CESSNA SAFETY ENHANCEMENT PROGRAM

SINGLE ENGINE SERVICE BULLETIN

SEB92-27

REDUCED DIAMETER VENTED FUEL CAP INSTALLATION AND TURBO PLACARD REMOVAL

Figure 1. Fuel Cap & Adapter Modification

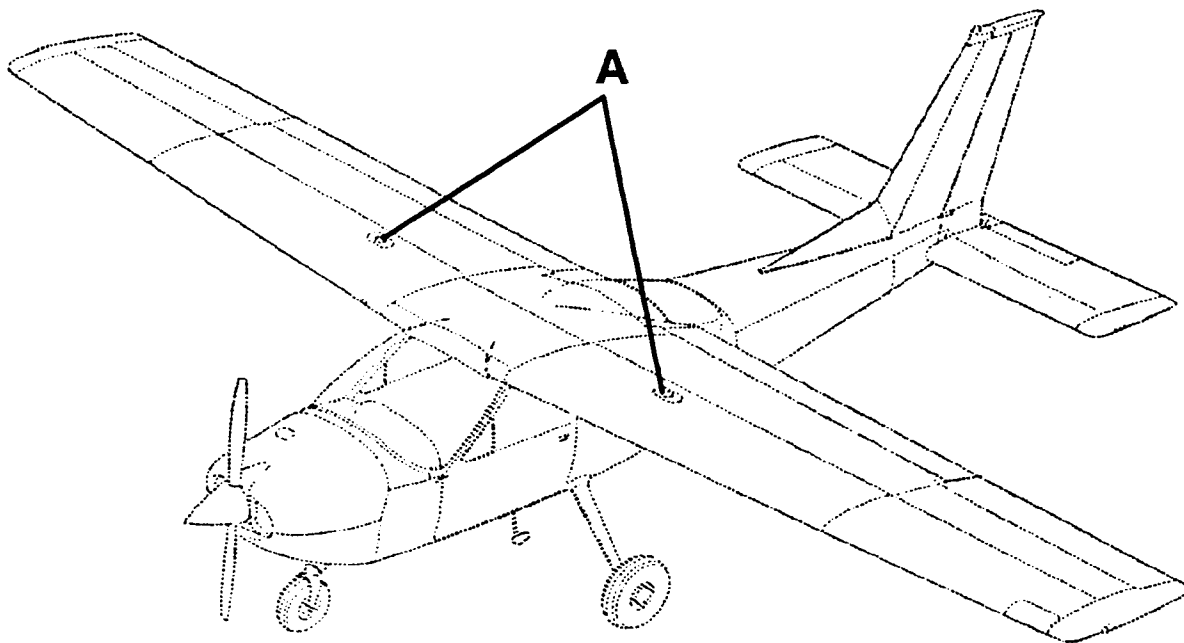
- Description of Installation.
 - Draining fuel from tanks.
 - Removing existing fuel filler door assemblies with cap and adapter assemblies.
 - Installing and sealing new filler door assemblies furnished in kit.
 - Installing placards removed for this installation.
- Installation Instructions.
 - (Refer to Figure 1.) Fuel Cap and Adapter Modification.
 - Drain fuel from both RH and LH wing tanks.
 - Remove existing filler door assembly, which includes cap, adapter and chain assembly, discard filler door assembly, retain screws (3).
 - Clean off all old sealer remaining on the filler door assembly cavity, on leading edge upper skin (4).

NOTE: Be sure and check fuel cell for dirt, old sealer, etc. that may have fallen into fuel cell. Clean or vacuum as required.
 - Apply CMNP022CLASSB1/2 sealer per instructions on container and appropriate Service Manual sealing procedures, to the faying surface (6) on door assembly (7). Cure time for sealer is 24 hours at approximately 77° F (25° C) and 50% relative humidity.

NOTE: Be sure and position the filler door assembly with the slotted opening of the indicator guard forward.
 - Install new filler door assembly (7) and secure with retained screws (3).

- (6) Attach chain assembly (2) to filler door assembly (7) and cap assembly (1).

Figure 1. Fuel Cap & Adapter Modification

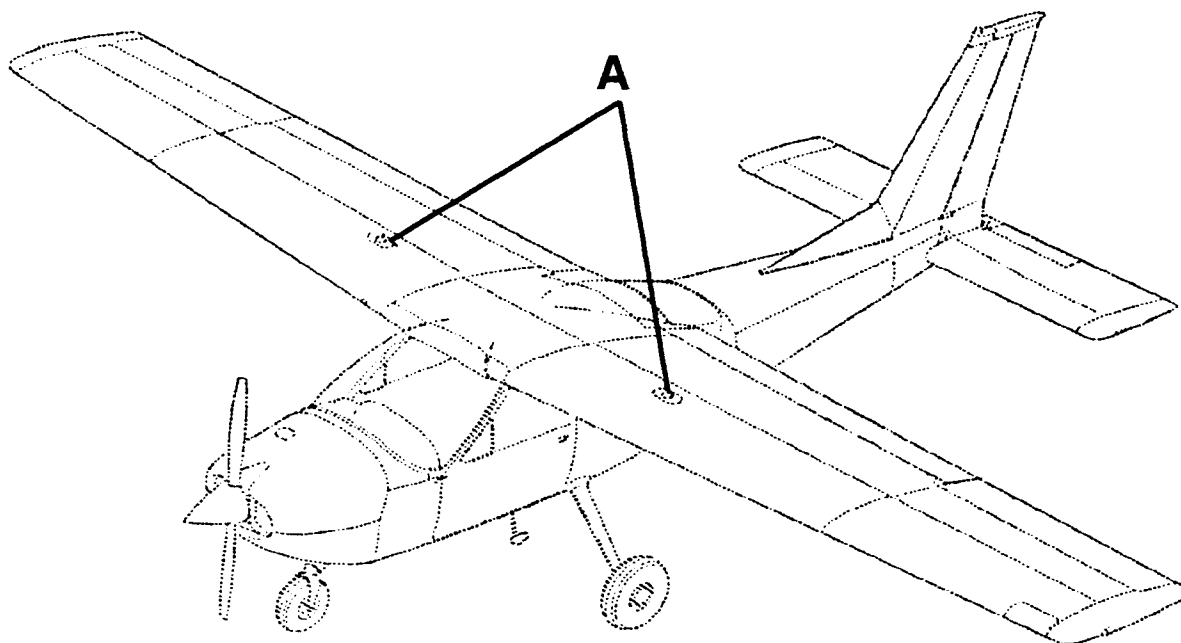
- Description of Installation.
 - Draining fuel from tanks.
 - Removing existing fuel filler door assemblies with cap and adapter assemblies.
 - Installing and sealing new filler door assemblies furnished in kit.
 - Installing placards removed for this installation.
- Installation Instructions.
 - (Refer to Figure 1.) Fuel Cap and Adapter Modification.
 - Drain fuel from both RH and LH wing tanks.
 - Remove existing filler door assembly, which includes cap, adapter and chain assembly, discard filler door assembly, retain screws (3).
 - Clean off all old sealer remaining on the filler door assembly cavity, on leading edge upper skin (4).

- Apply CMNP022CLASSB1/2 sealer per instructions on container and appropriate Service Manual sealing procedures, to the faying surface (6) on door assembly (7). Cure time for sealer is 24 hours at approximately 77° F (25° C) and 50% relative humidity.

- (5) Install new filler door assembly (7) and secure with retained screws (3).
NOTE: Be sure and position the filler door assembly with the slotted opening of the indicator guard forward and slightly outboard for both the RH & LH filler door assemblies, 2009015-5 for the LH wing and 2009015-6 for the RH wing..
 - (6) Attach chain assembly (2) to filler door assembly (7) and cap assembly (1).
NOTE: Replace all placards removed during this modification. Refer to the appropriate Parts Catalog for part numbers. Install S2608-1 GAMA fuel placard near fuel filler.
 - (7) Repeat these same procedures for the opposite wing.
 - (8) After completion of this modification, refuel airplane.
3. Make an entry in the airplane logbook stating this service kit has been installed.

Figure 1. Fuel Cap and Adapter Modification

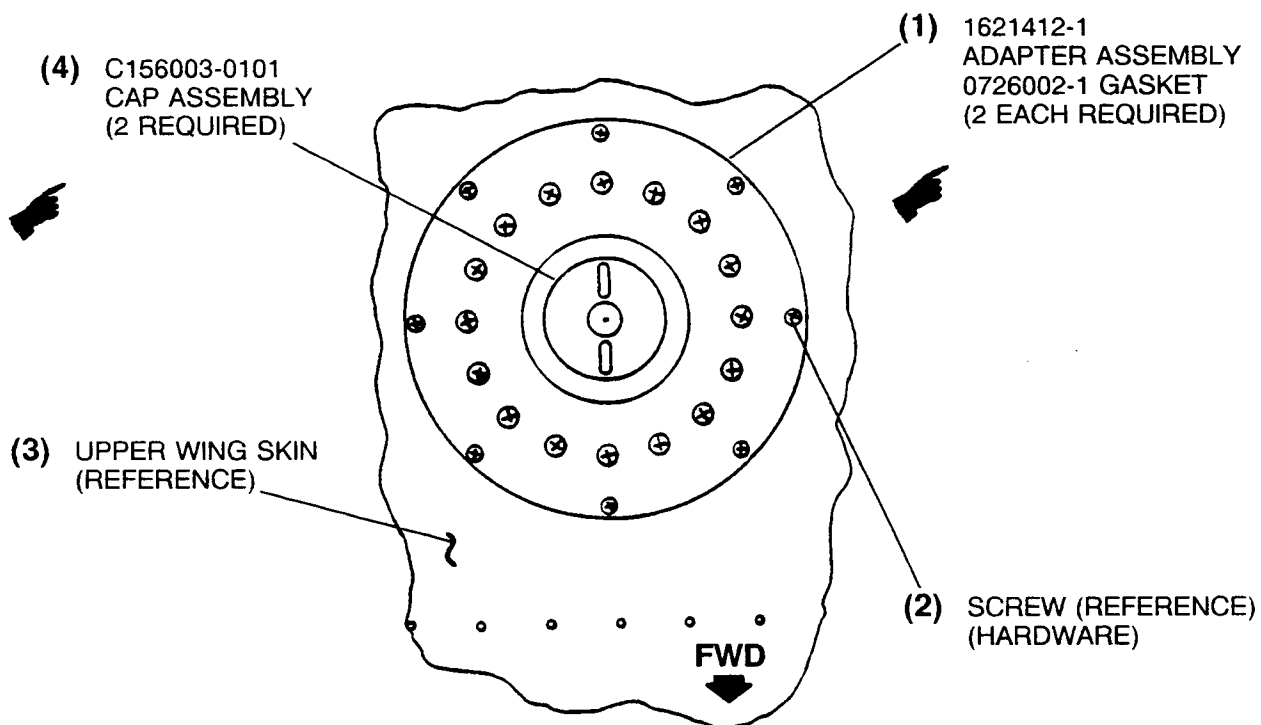
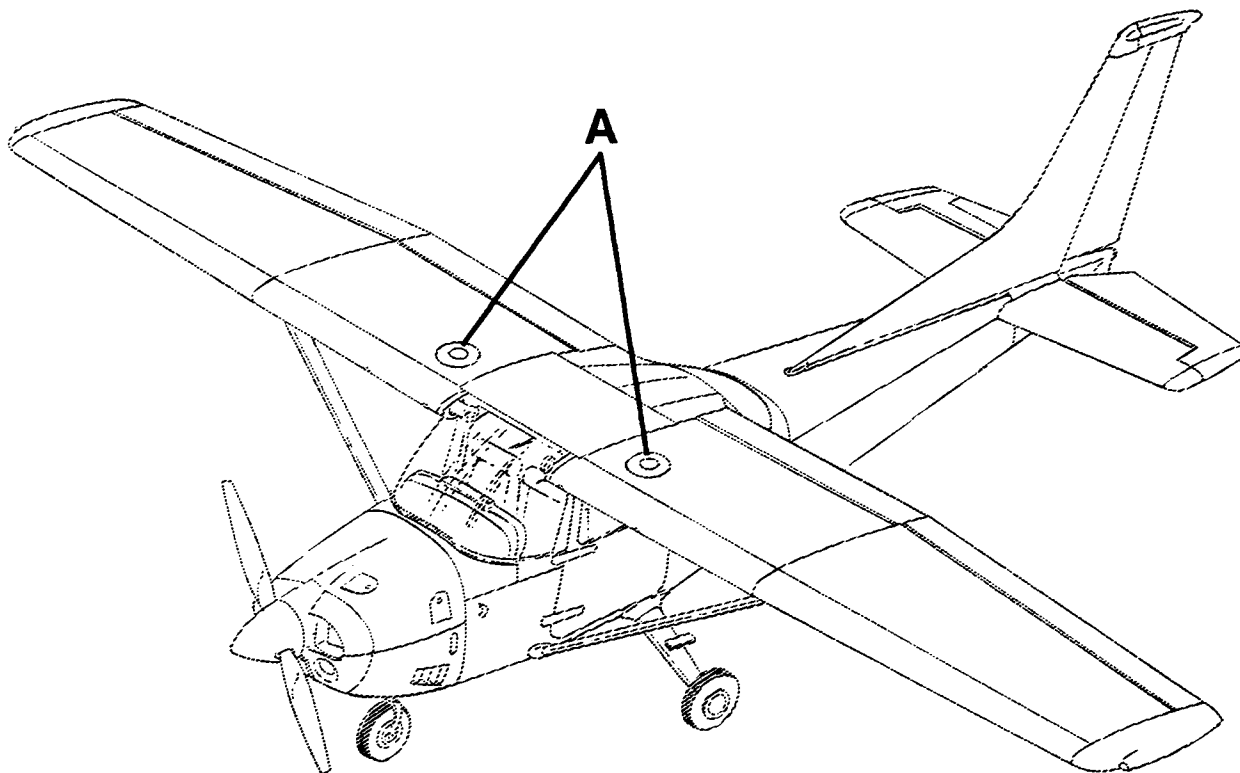
- Installation of this kit consists of:
 - Draining fuel from tanks.
 - Removing existing fuel cap and adapter assembly.
 - Installing new gasket, adapter, and cap assembly.
 - Installing new placards removed for this modification.
- Installation Instructions.
 - Drain fuel from both RH and LH wing tanks.
 - Remove existing fuel cap adapter in location (1), with existing cap assembly (4) and gasket. Retain hardware, discard fuel cap, chain, and adapter assembly.

NOTE: Be sure and check fuel bladder for dirt or foreign matter that may have fallen into bladder. Clean or vacuum out bladder as required.
 - Install new adapter assembly (1) with 0726002-1 gasket furnished in kit, using retained hardware (2) removed in step (2).

NOTE: Install adapter assembly with the long side of internal filler neck extension forward.

D. Attach chain assembly to cap assembly (4), and adapter assembly (1).

Figure 1. Fuel Cap and Adapter Modification

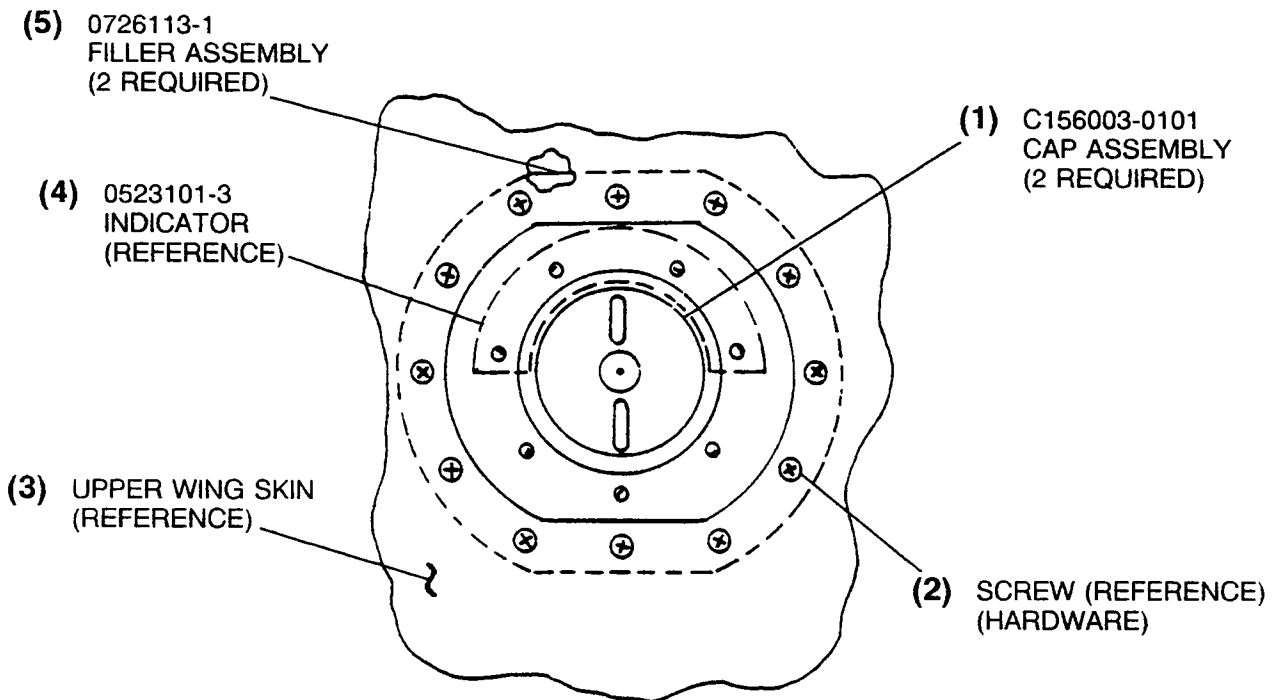
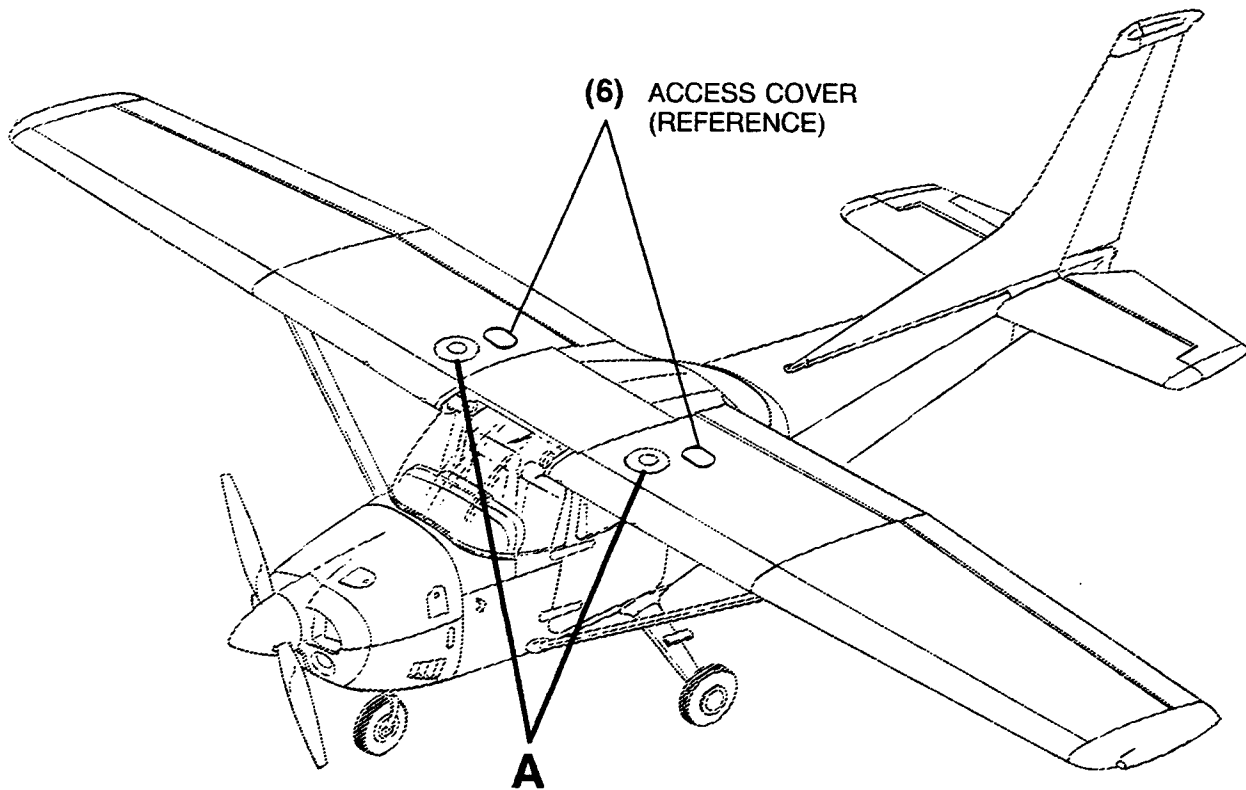
1. Description of Installation.
 - A. Installation of this kit consists of:
 - (1) Draining fuel from tanks.
 - (2) Removing access cover and fuel cap adapter assembly.
 - (3) Installing and sealing new filler assembly. Installing and resealing new access covers.
 - (4) Installing new placards removed for this modification.
2. Installation Instructions.
 - A. (Refer to figure 1.) Fuel Cap and Adapter Modification.
 - (1) Drain fuel from both RH and LH wing tanks.
 - (2) Remove access cover (6), retain cover and hardware.
 - (3) Remove existing fuel cap assembly, retain all hardware. Discard fuel cap, chain, and adapter assembly.
 - (4) Clean off all old sealer remaining on fuel filler and access cover cavities in the wing.

- (5) Apply CMNP022CLASSB1/2 sealer to filler assembly (5) per instructions on the container and appropriate Service Manual. Insert filler assembly (5) thru access hole (6) and install as shown with retained hardware. Cure time is 24 hours at approximately 77° F (25° C) and 50% relative humidity.

NOTE: Install filler assembly (5) with the long side of indicator (4) in the aft position.

- (6) Attach chain assembly to cap assembly (1), and filler assembly (5).
- (7) Apply sealer to access cover (6) per instructions on container and appropriate Service Manual sealing procedures. Reinstall with retained hardware. Cure time for sealer is 24 hours at 70° F.
